Flood Impact and Risk Assessment Report

40 Memorial Avenue,
Bella Vista

| Revision 07

Table 1 - CPHR RFI Comments Register (Ref DOC25/900849)

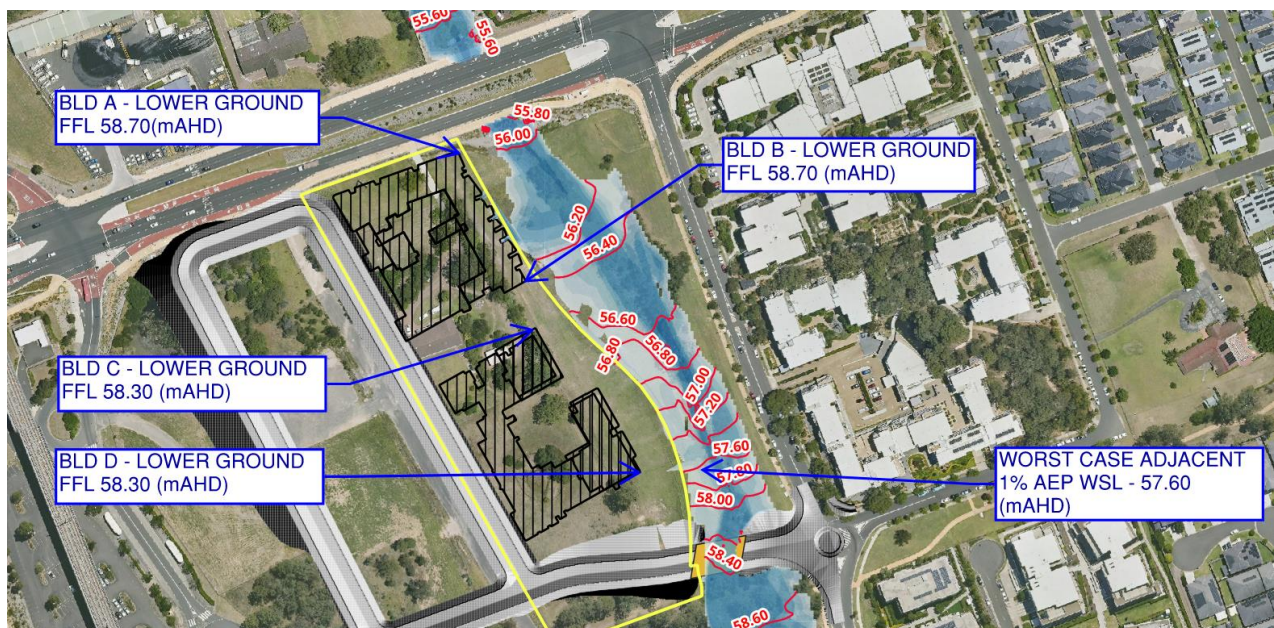
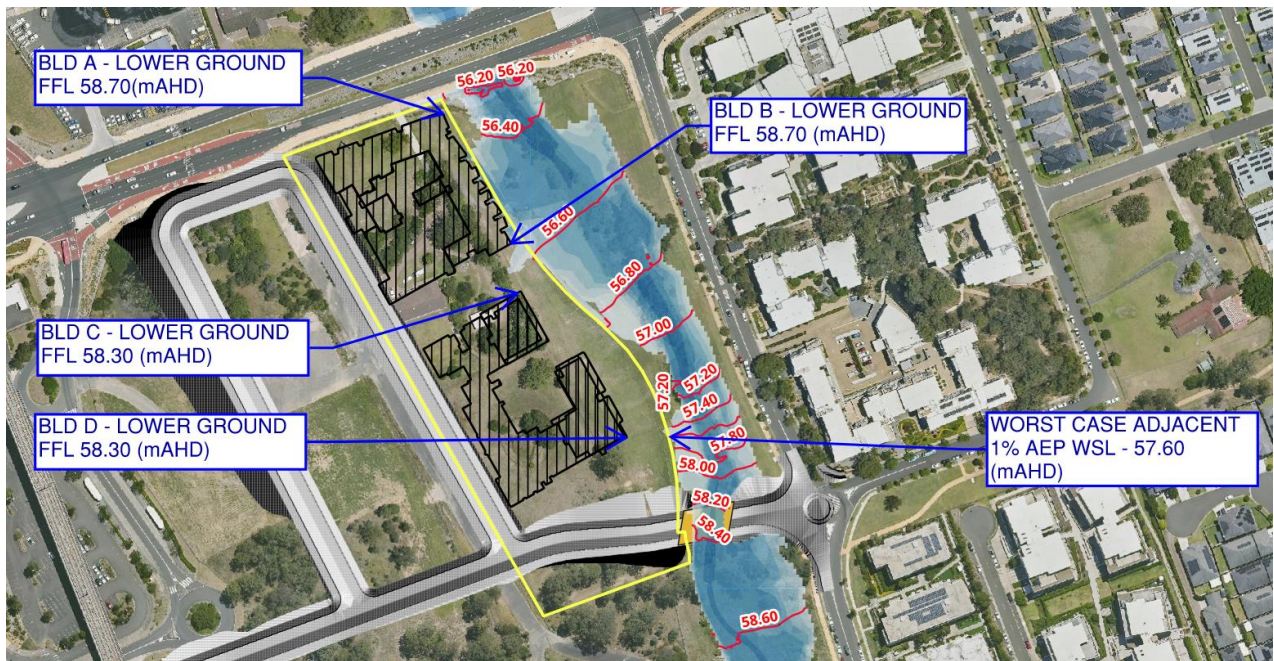
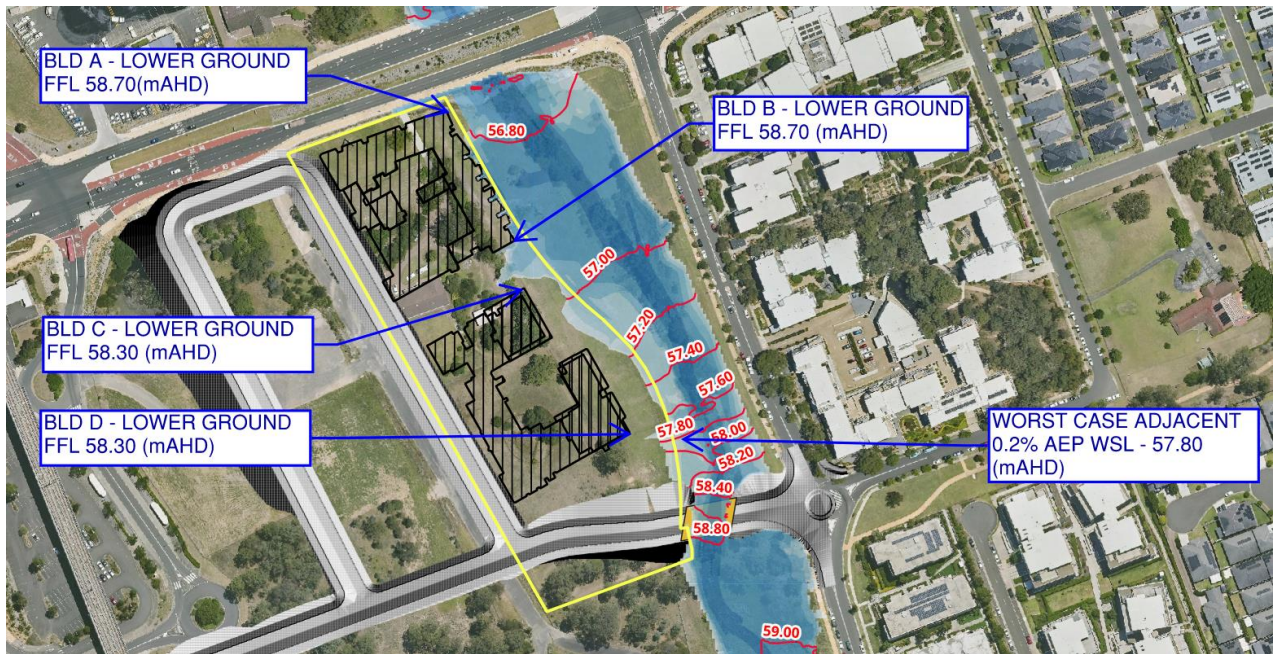
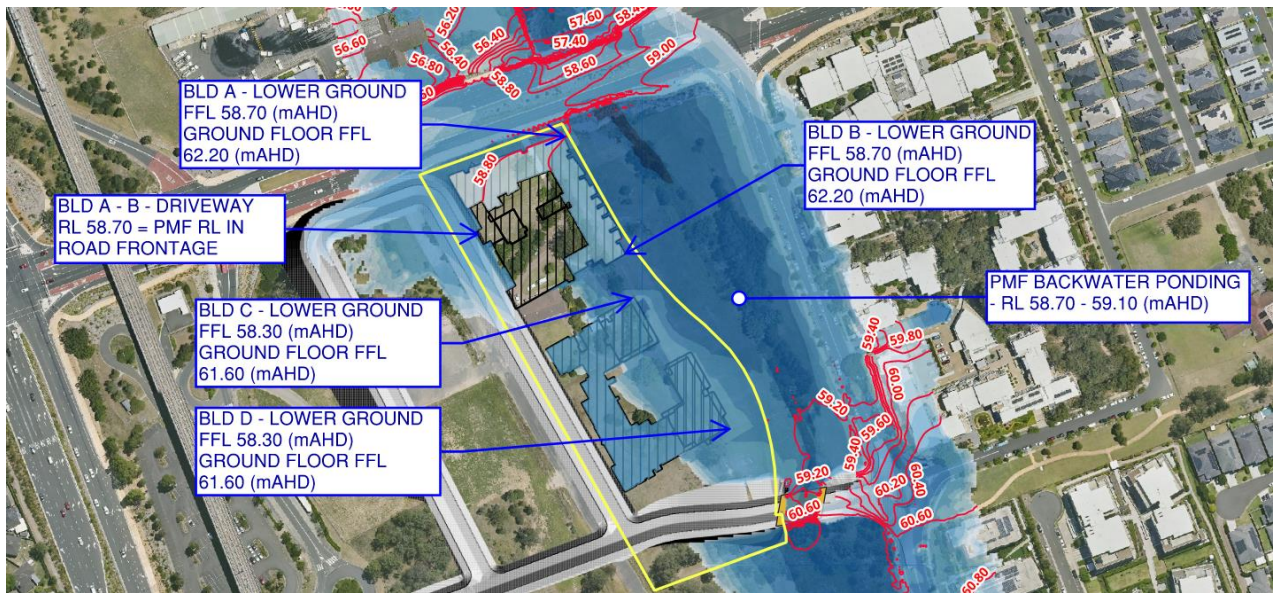
2	Buildings C and D do not meet flood planning requirements for floor level	The FIRA shows that in the ultimate development scenario only 300mm of freeboard is achieved for Buildings C and D. This is not consistent with the required flood planning levels of 500mm above the 1% Annual Exceedance Probability (AEP) flood level.	We disagree. The proposed Lower Ground Floor level is RL 58.30 m AHD (lowest habitable floor RL for Buildings C and D). The highest adjacent 100 Year (1% AEP) water surface level within Elizabeth Macarthur Creek is just below 57.70 mAHD giving at least 0.6m at the worst case location in the south eastern most corner of building C and D (outside and adjacent to Unit 22). Moving downstream, the water surface levels within the creek drop, with a water surface level of 56.90m outside the frontage of Unit 15 (increasing the freeboard available to FFL RL 58.30 mAHD).	The mapping is missing contours in some areas and it is not possible to read floor levels within the FIRA figures. Section 7.1 contradicts the statement made in this spreadsheet. It is recommended that flood levels and floor levels be clearly set out at each entry point once the model has been updated to show building footprints separately from landscaped areas where flow may occur.	Building Footprint has been fully digitised against Architectural Layouts for the Lower Ground Floor. Architectural Plans included in Appendix for ease of reference. All habitable dwellings are above the Flood Planning Level. Refer to architectural plan extracts and floor versus flood level summaries in Section 3.

Figure 16 The size of computational cells inside and outside of the study site

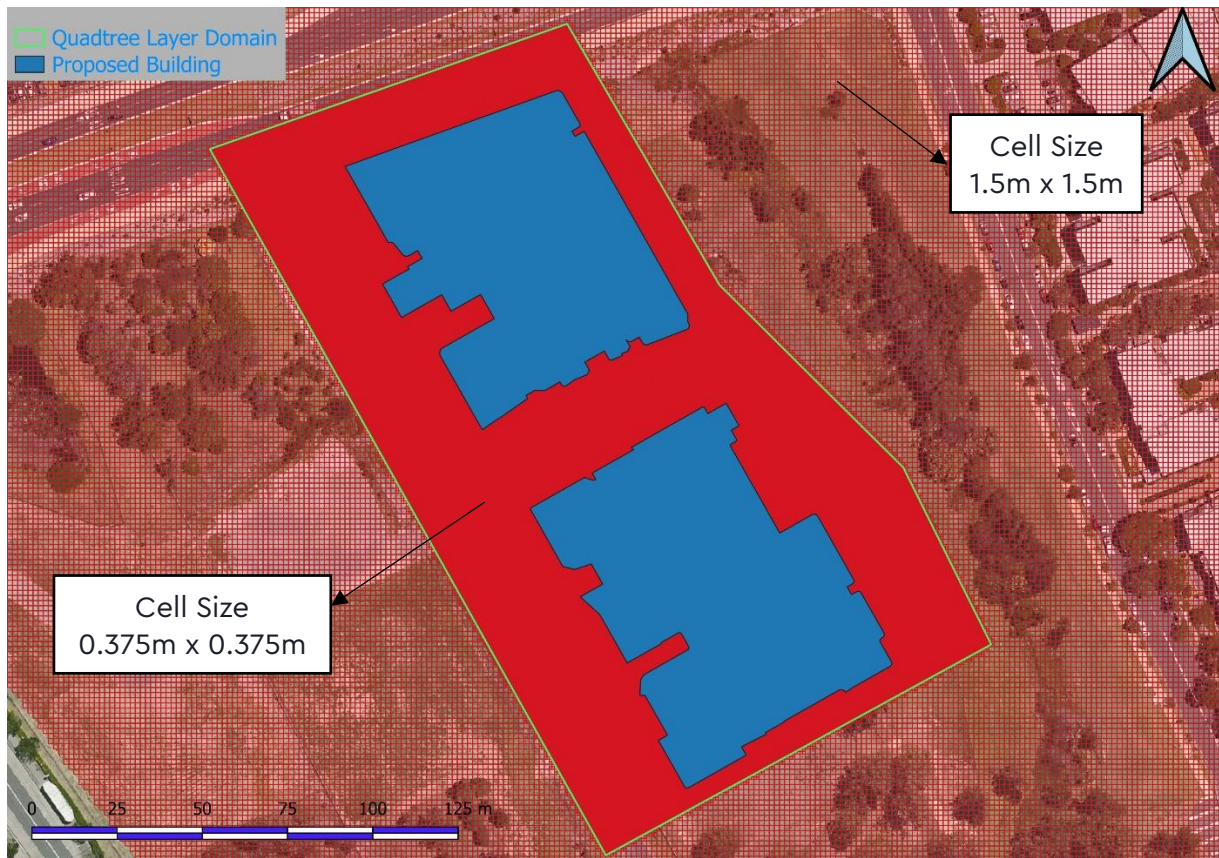
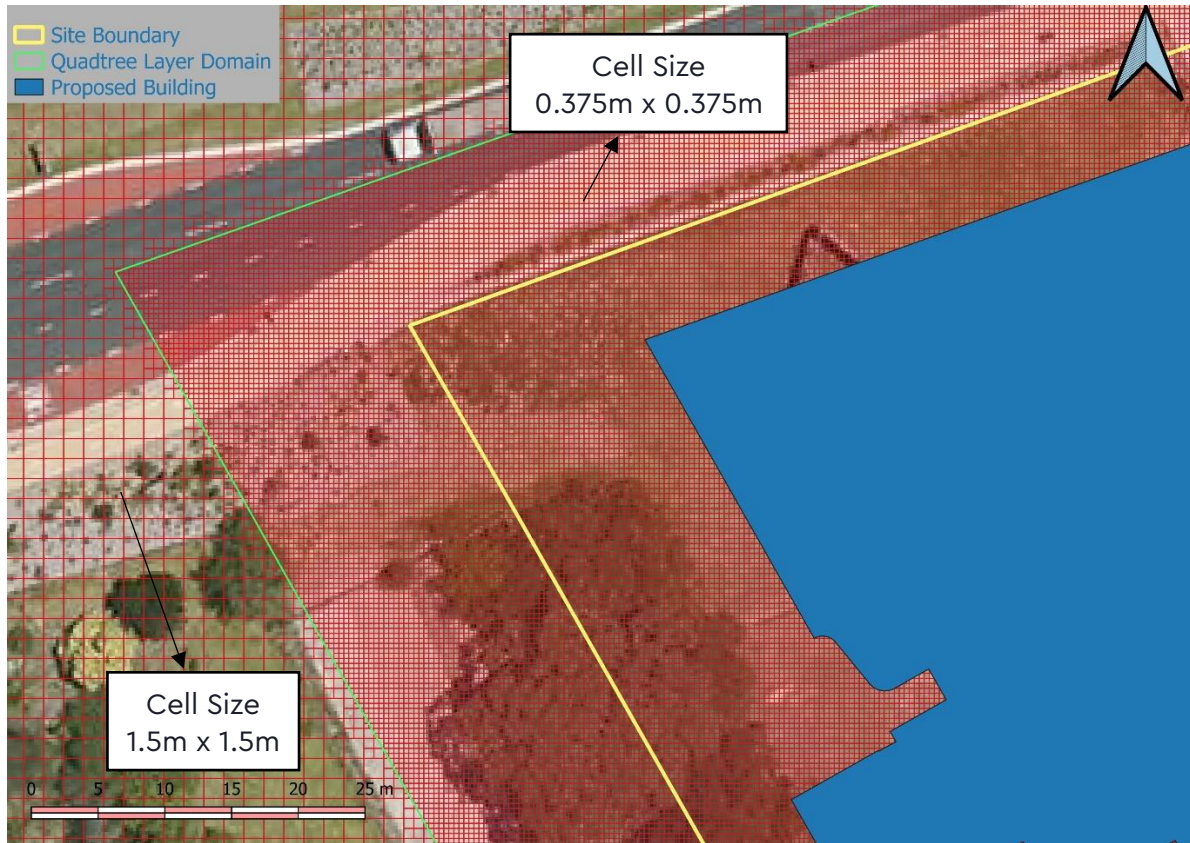
10	Too large grid size for afflux determination	The model uses a 4sqm grid size. This may not be fine enough to model flow around and through buildings or adequately represent afflux.	<p>We disagree. A 2m grid is standard practice for a model of this nature and adequately achieves the minimum accepted industry standard for approximately 3 cells to capture any significant flow paths within the 2D domain.</p> <p>A significantly reduced grid size (resolution increase) is computationally impractical and not standard practice because of this reason.</p> <p>However, a 1.5m grid will be adopted to respond to this request (any smaller and we hit computational memory restrictions on the HPC analysis).</p>	No afflux mapping has been provided therefore it is not possible to determine at this stage if the grid size is adequate.	Afflux Maps Provided, Quadtree Domain incorporated to increase localised modelling resolution

Rev 07	2026.03.04	6.2.3 Model Cell Size	The cells size in the site area and over the proposed buildings reduced to 0.375mx0.375m	Proposed buildings have elements with the size of less than 1m. As a result, the cells size over the proposed buildings reduced to increase the grid resolution and capture more proposed buildings details
Rev 07	2026.03.04	6.2.5 Hydraulic Roughness	Change material layer for Interim Development scenario as shown in Figure 18	To match the material layer information with Interim Development surface
Rev 07	2026.03.04	6.3.3 Model Cell Size	The cells size in the site area and over the proposed buildings reduced to 0.375mx0.375m	Proposed buildings have elements with the size of less than 1m. As a result, the cells size over the proposed buildings reduced to increase the grid resolution and capture more proposed buildings details
Rev 07	2026.03.04	6.3.5 Hydraulic Roughness	Change material layer for Ultimate Development scenario as shown in Figure 19	To match the material layer information with Ultimate Development surface

Figure 21 - Ground Floor Level Surveys of No. 2 Free Settlers Drive (By Registered Surveyor, Orion 11/02/2026)

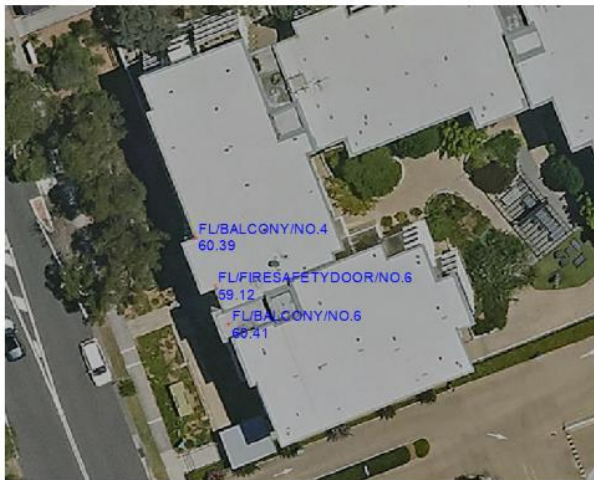
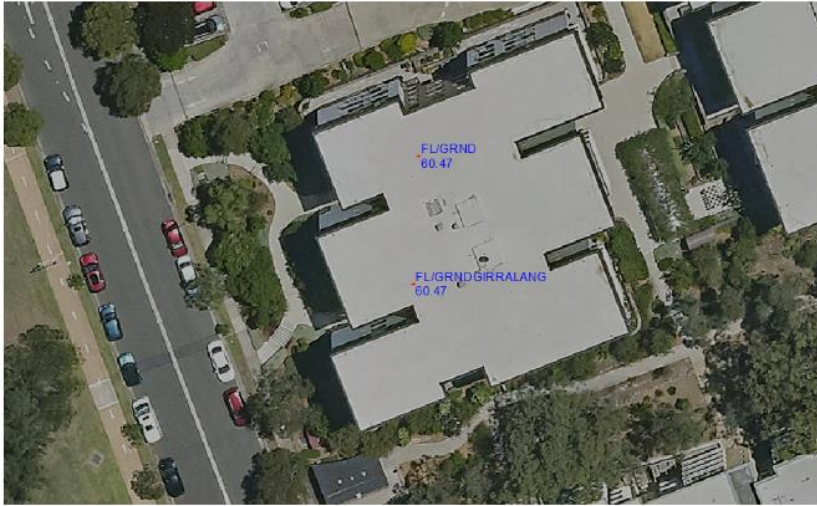
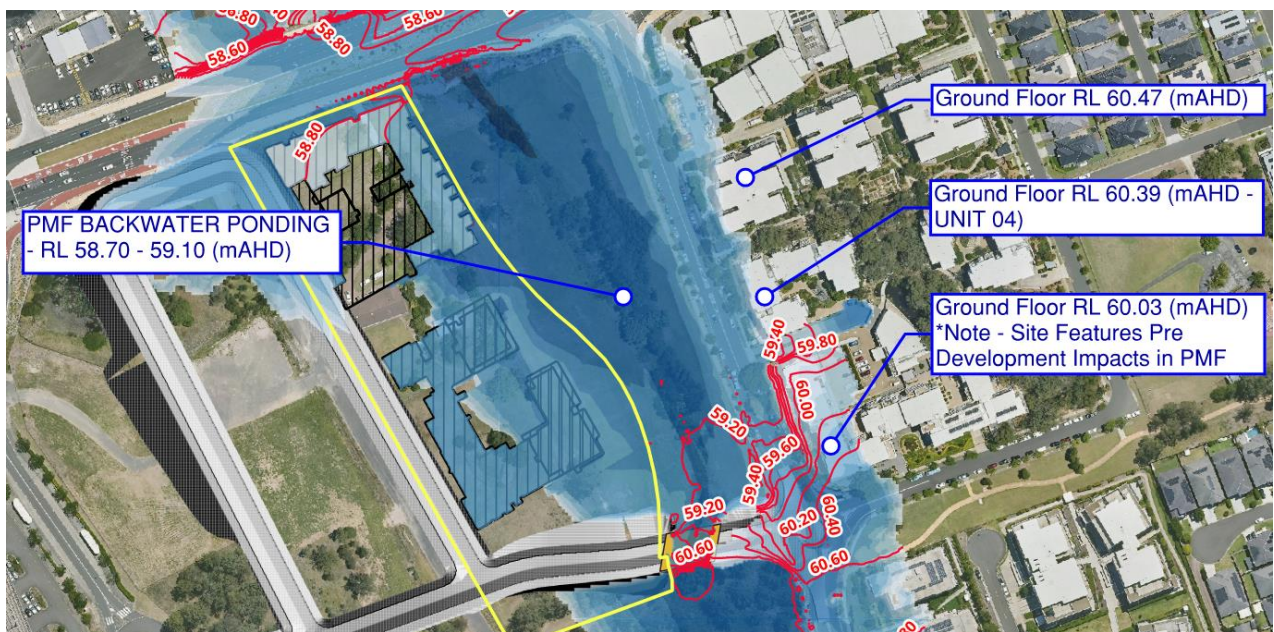
9	Buildings A and B are surrounded by high hazard floodwaters in the PMF event	The FIRA indicates that the proposed Buildings A and B will be surrounded by H4 and H5 floodwaters in the PMF event. H3 floodwaters impact the creek side of buildings in the 1% event. This poses significant risk to life and the potential for damage to structures. Escape via vehicle is not feasible due to the basement entry location and escape on foot is likely to be found unviable once the buildings are correctly presented in the model. The current design also appears to connect the basement for Buildings C and D from Building A. The flood levels shown indicate that Buildings A and B will be inundated well above habitable floor levels in a PMF event and significant quantities of water will be able to enter the proposed basement.	Refer to response under point 6) above. Changes to the design requirements around shelter in place for short duration PMF impacts need to be coordinated with CPHR prior to any design amendments and actioning by the project team.	Refer to the comments above

To validate and understand any risks associated with the localised PMF impacts, a floor levels survey was undertaken for a selected number of units from the footpath reserve of Free Settlers Drive by registered surveyor. The figure 21 above shows these reduced levels by survey for reference.

These floor levels transcribed and are shown in the PMF extract figure below and demonstrates that all existing buildings within the No. 2 Free Settlers Drive frontage are above the PMF flood level.

The buildings with floor levels of RL. 60.47 and 60.39 are above the PMF flood level. The building at the corner of Hodges Road and Free Settlers Drive with floor level 60.03 is shown to have minor PMF affectation within this model in both Pre and Post Development Scenarios with no change in risk or impact due to the proposed development.
